Technical Bulletin

Subject: Exterior Rear-view Mirror, Wind Noise

Number: 99-04

Model(s): A4

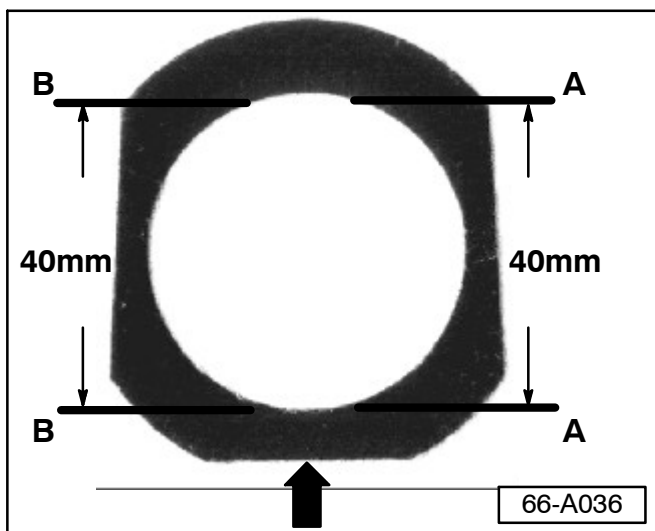
- Remove tape.
- Cut a 40mm strip from adhesive backed felt washer Part No: 8D0 857 555 (allows felt washer to slip past mirror wiring harness).

◀ Illustration shows washer (felt side up, adhesive side down).

- ◆ Cut at -A- for left mirror.
- ◆ Cut at -B- for right mirror.
- ◆ Flat edge of felt washer -arrow- faces away from vehicle.
- Fold door mirror towards body.

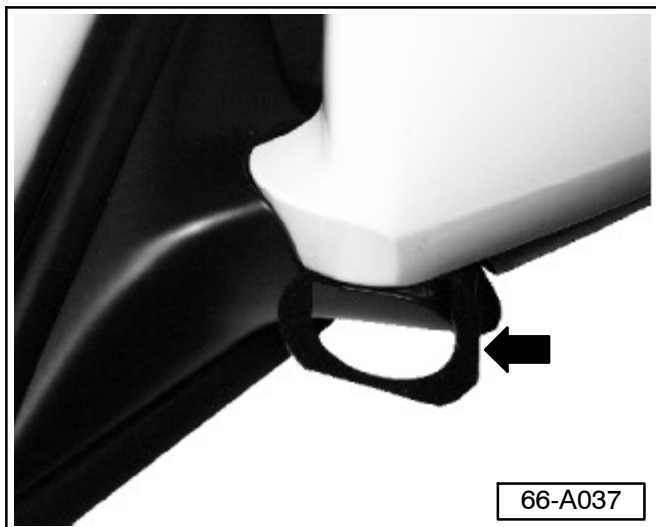
- Clean surface behind mirror (area where felt washer will be installed).
- Tilt mirror towards the rear.
- Remove backing from felt washer and slide felt washer below mirror housing, then press into place (flat edge of gasket -arrow- to the outside as shown).
